Docket Item #11  
DEVELOPMENT SPECIAL USE PERMIT #2003-0036  
PICKETT'S RIDGE

Planning Commission Meeting  
February 3, 2004

**ISSUE:** Consideration of a request for a development special use permit amendment, with site plan and subdivision, for construction of two single family dwellings.

**LOCATION:** 3 Buzzard's Gap

Trees Saved or Planted in Green  
Trees to be Removed in Red

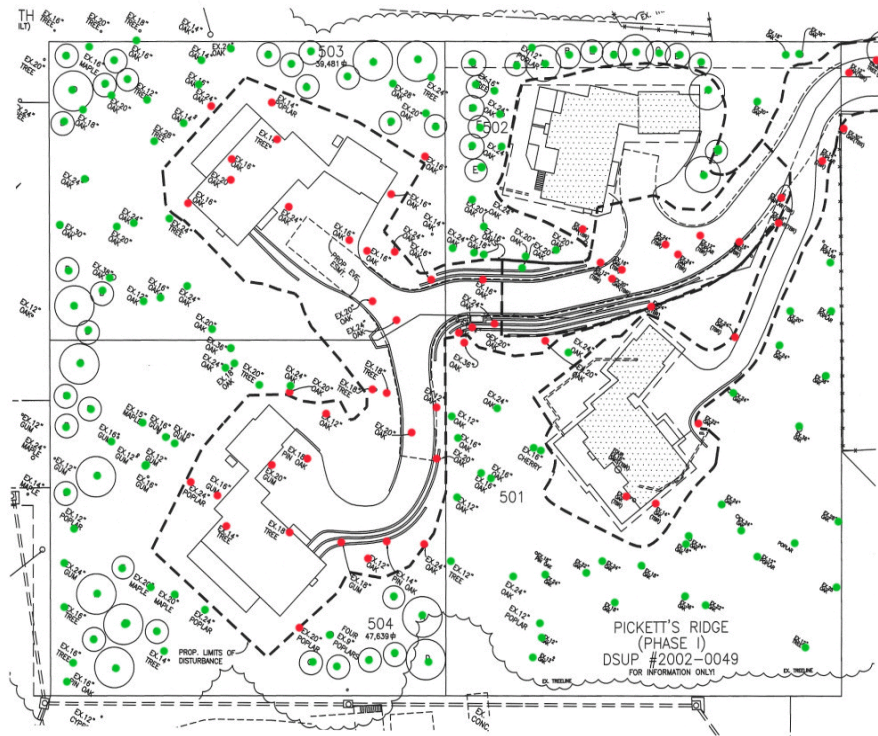
Although a substantial portion of the site is to be preserved, staff believes that it is important to assure long-term protection of these natural areas. However, one particular issue involving the necessary emergency vehicle access and turnaround for Phase II redevelopment has resulted in a significant impact or potential loss of a 36" Oak tree that had been designated for saving on the Phase I site. The road grades for an emergency vehicle turnaround have to be relatively flat to insure that emergency vehicles can safely ingress and egress from the Phase II site. To flatten the grades requires that road be lowered to a lower elevation than had been proposed. This results in additional stepped retaining walls which now encroaches on the 36" Oak that had been designated to be saved. Staff believes the applicant should provide compensation for the loss of the tree by either paying \$10,000 to the City or by providing for additional trees with a total caliper equal to the diameter of the tree being removed.

With regard to other areas of the site that are designated for preservation staff is recommending that they be placed in a conservation covenant as was done on Phase I. Staff is also recommending conditions restricting the use of the conservation area, including a prohibition for the future erection of fencing. The recommendations also include a provision that the applicant is required to notify prospective purchasers of the covenant stipulations.
